**Re: Ex Parte Presentation, *Expanding Flexible Use of the 3.7-4.2 GHz Band*, GN Docket No. 18-122**

CTIA submits the following response to the Study filed by the Aerospace Vehicle Systems Institute (“AVSI”) on July 2, 2020 with regard to co-existence and interference risks between new 3.7 GHz Services and altimeter operations in the 4.2-4.4 GHz band.<sup>1</sup> The Study does not provide an adequate evidentiary basis for its alleged findings regarding interference, as described below. CTIA encourages stakeholders within the aviation community to provide sufficient data for any findings going forward, preferably within the multi-stakeholder Technical Working Group Sub-Group 3 (“TWG-3”), “5G/Aeronautical Coexistence,” which is charged with considering these very issues.

Figure 10: Minimum Break Points of Altimeter Types 1 – 6 for Each Altitude Tested.

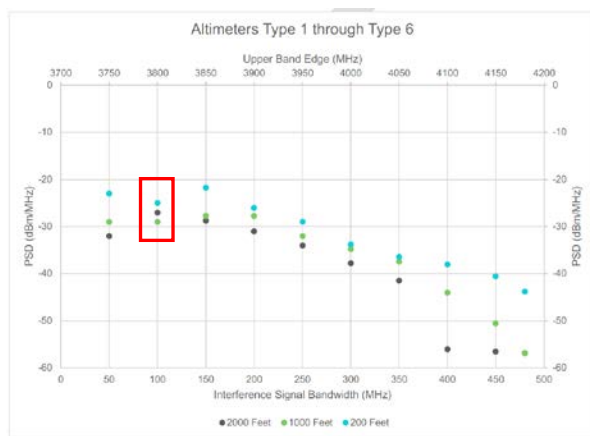
AVSI's test results show Altimeter Type 7 is an outlier device. AVSI's Preliminary Report submitted in October 2019 contained data in Figure 10 and Figure 11 reproduced below that show test results for the worst of Altimeters Types 1-6 and a separate figure for Type 7.<sup>11</sup> We add the red boxes to highlight and compare performance for a 100 megahertz-wide interfering signal operating at 3800 MHz. The worst altimeter of Types 1-6 performs more than 20 dB better than Type 7.

Further, Altimeter Type 7 showed additional anomalous results as compared to the other six altimeters AVSI measured in the area of receiver resiliency versus altitude. The Altimeter Types 1-6 chart above shows the best performance at the 200 feet altitude level, and has increasing susceptibility as a function of altitude, with 2000 feet being the most sensitive to interference. Outlier Altimeter Type 7’s results are anomalous and not at all predictable—the 2000 feet altitude shows the least impact, with 200 feet next, and 1000 feet being the most susceptible to interference. This could be an indication that Altimeter Type 7 may not have been operating properly during testing.

Figure 7: Aggregate Plot of Altimeter Break Points, 200 Feet.

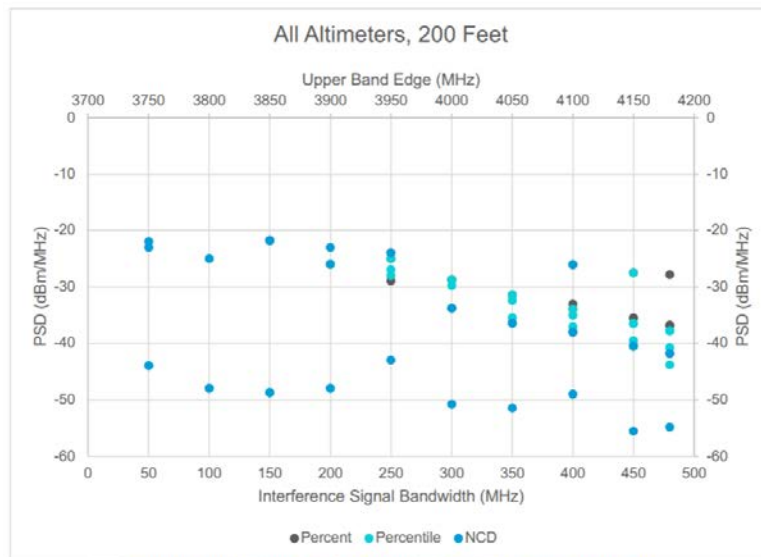
Additionally, the data AVSI presents identifies an interference tolerance threshold of -47 dBm/MHz for Altimeter Type 7, and here that threshold appears to have been triggered only by a NCD flag. AVSI describes NCD as a situation whereby “unreliable altitude readings are output on the 429 bus along with an error flag that indicates No Computed Data (NCD).”<sup>12</sup> This flag is proprietary to the altimeter vendor and reveals no performance criteria whatsoever. As AVSI observes, “[c]riteria for reporting NCD can vary with the specific signal processing design in the various altimeters, but it is generally indicative of a condition in which the signal-to-noise ratio of the received [frequency modulated continuous wave] signal is insufficient to compute an altitude with the required level of confidence.”<sup>13</sup> AVSI's Preliminary Report submitted in October 2019 contained a Figure 7 reproduced

below that indicates that the Altimeter Type 7 interference determination is always based on the NCD condition.<sup>14</sup>

AVSI does not provide any indication as to the actual altitude determinations, only that the altimeter made a proprietary determination that the altitude is “unreliable.”

Further, Figure 7 from AVSI’s Preliminary Report submitted in October 2019 does not provide any delineation as to individual altimeter performance, thus the only information that can be obtained from Figure 7 and applied for an individual altimeter is the outlier Altimeter Type 7. The variations in individual altimeter performance are essential to ensure the studies assess real-world situations, and are not focused on the worst of several specifications that would never be deployed together in practice. A robust analysis would require individual empirical altimeter performance data both in terms of its receiver overload thresholds and its filter rejection.
